DCR number	124	Changes required for: General	Originator: S Thacker
Date: 2004/06/08		Date sent: 2004/06/08	Organisation: ESA/ESTEC
Status: IMPLEMENTED

Title:	CMOS Quad 3-State NOR R/S Latches, based on type 4043B		
Number:	9202/042	Issue:	1

FIGURE 3(c) - CIRCUIT SCHEMATIC (EACH LATCH)

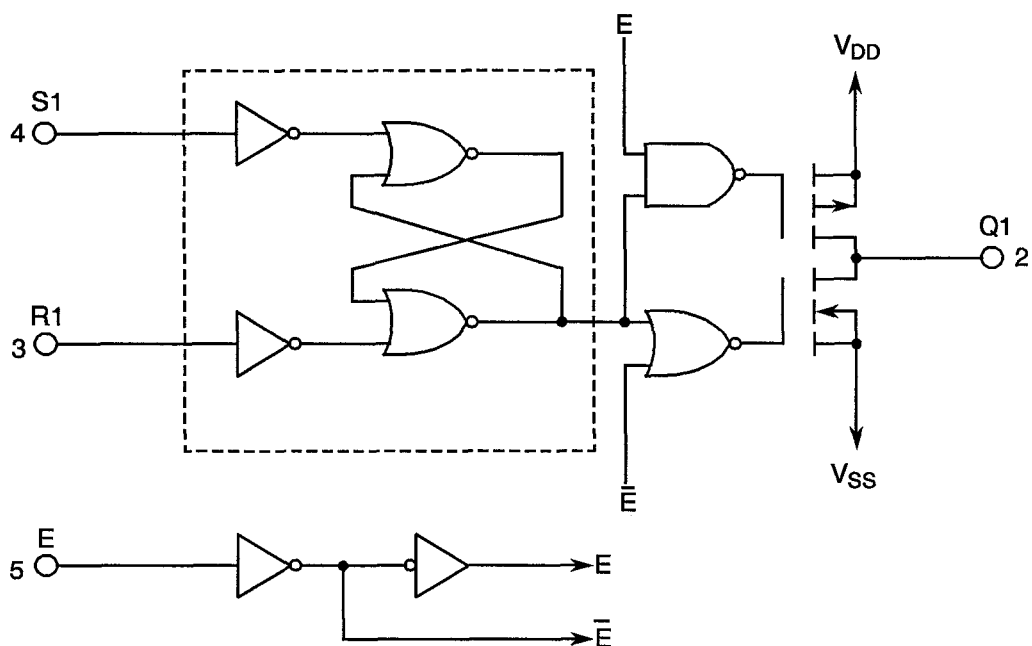
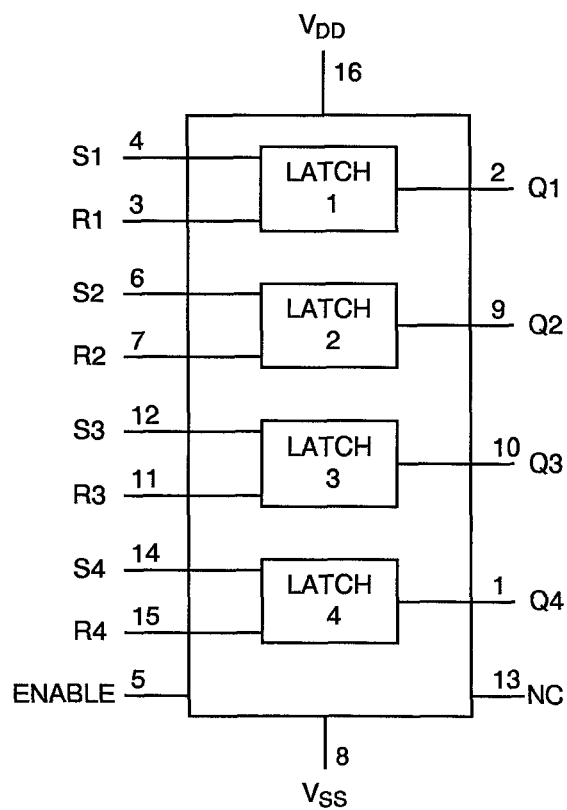
Figure is amended to reflect an equivalent NOR Latch (as para 1.8 Functional diagram in amended spec) - see original and amended version as attached.

Original figure was incorrect (it was an equivalent NAND Latch)
